Docket Nos.: 50-443
and 50-444

Subject: Request for Additional Information

The NRC staff has determined that additional information is required for the safety review of the Seabrook operating license application. Enclosed are the following Requests for Additional Information (RAIs):

Diagram 2A

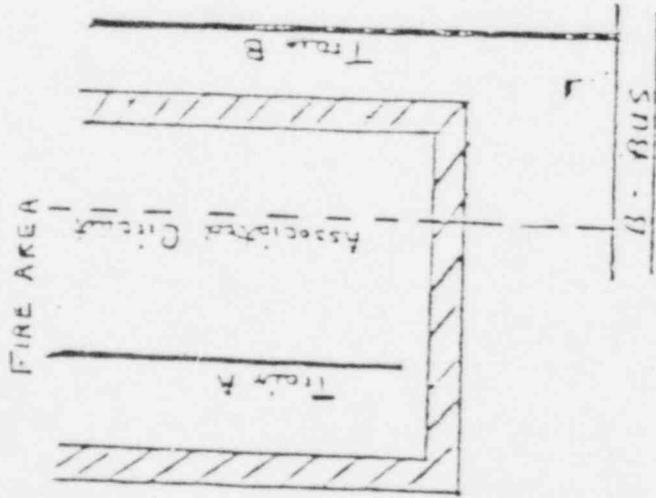
1. Have a physical separation less than that required by Section III.G.2 of Appendix R, and;
2. Have one of the following:
 - a. a common power source with the shutdown equipment (redundant or alternative) and the power source is not electrically protected from the circuit of concern by coordinated breakers, fuses, or similar devices (see diagram 2a), or

2. a. For a common power source case of associated circuit:

Provide load fuse/breaker (interrupting devices) to feeder fuse/breaker coordination to prevent loss of the redundant or alternative shutdown power source. To ensure that the following coordination criteria are met the following should apply:

Diagram 2B

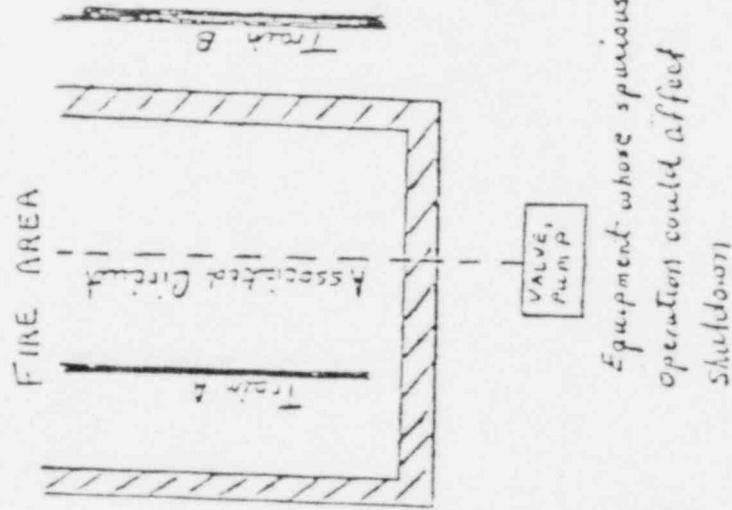
- b. a connection to circuits of equipment whose spurious operation would adversely affect the shutdown capability (e.g., RHR/RCS isolation valves, ADS valves, PORVs, steam generator atmospheric dump valves, instrumentation, steam bypass, etc.) (see diagram 2b), or

- b. For circuits of equipment and/or components whose spurious operation would affect the capability to safely shutdown:

- (1) provide a means to isolate the equipment and/or components from the fire area prior to the fire (i.e., remove power cables, open circuit breakers); or
 - (2) provide electrical isolation that prevents spurious operation. Potential isolation devices include breakers, fuses, amplifiers, control switches, current XFRS, fiber optic couplers, relays and transducers; or
 - (3) provide a means to detect spurious operations and then procedures to defeat the maloperation of equipment (i.e., closure of the block valve if PDRV spuriously operates, opening of the breakers to remove spurious operation of safety injection);
- c. For common enclosure cases of associated circuits:
- (1) provide appropriate measures to prevent propagation of the fire; and
 - (2) provide electrical protection (i.e., breakers, fuses or similar devices)

Diagram 2C

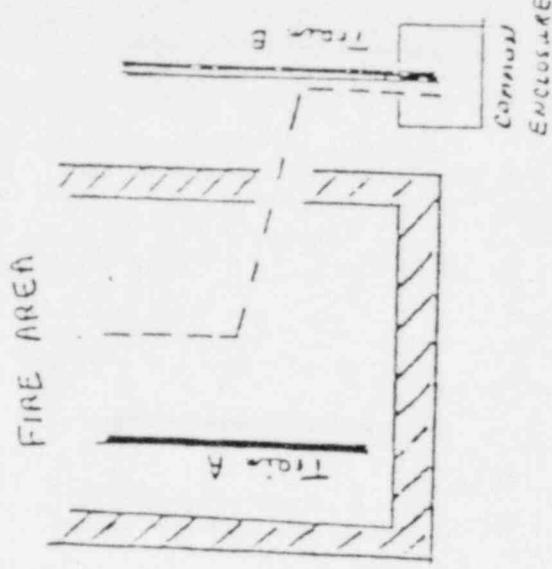
- c. a common enclosure (e.g., raceway, panel, junction) with the shutdown cables (redundant and alternative) and,
 - (1) are not electrically protected by circuit breakers, fuses or similar devices, or

- (2) will allow propagation of the fire into the common enclosure, (see diagram 2c).
